Record of Executive Business and Chief Executive's Order

Reg. Reference: SD22A/0373 **Application Date:** 29-Sep-2022

Proposed Development: Demolition of the existing former two storey steelworks factory (465sq.m) and build on resultant cleared site of circa 0.133 hectares; Construction of 3 flat roof, terraced, three storey, three bedroom houses (160sq.m each, 480sq.m total) with external terraces at first and second floor levels and all associated site development works above and below ground.

Location: Former steelworks factory, Manor Avenue, Terenure, Dublin 6W

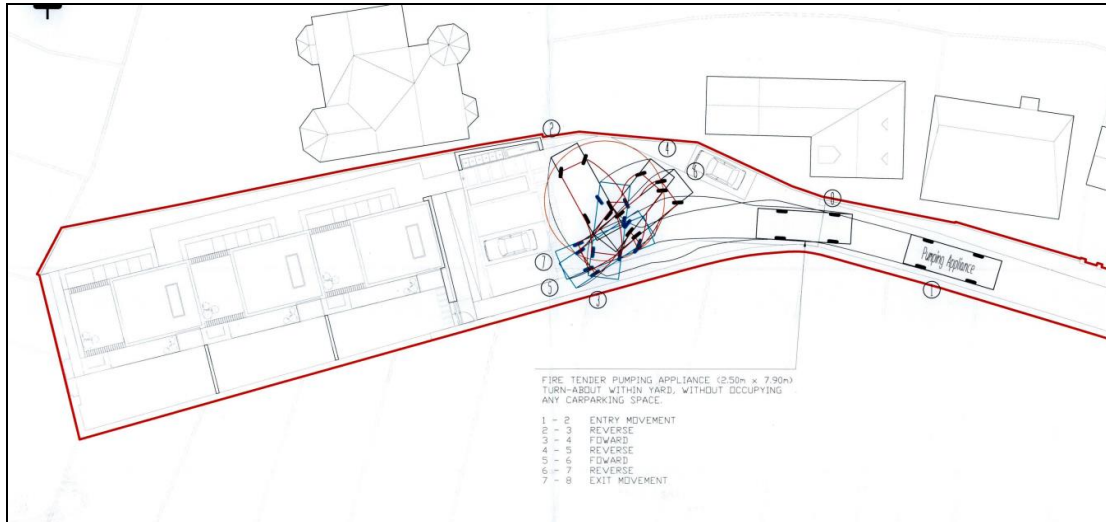
Due to the access laneway being narrow and lacking any pedestrian or public lighting facilities, it would be reasonable to assume that the vast majority of journeys to and from the site will be made by car. SDCC Roads Dept. therefore considers the parking provision to be low. This under provision could lead to the haphazard parking of residents and visitor's vehicles resulting in a traffic hazard.

The applicant has submitted a swept path analysis showing the turning movements of service vehicles on the site. SDCC Roads Dept. has serious concerns around the number and complexity of movements required for these vehicles to turn. Furthermore, the manoeuvrability of service vehicles is completely reliant on a clear path being available. As noted above, the low parking provision would increase the possibility of car being parked outside designated parking bays.
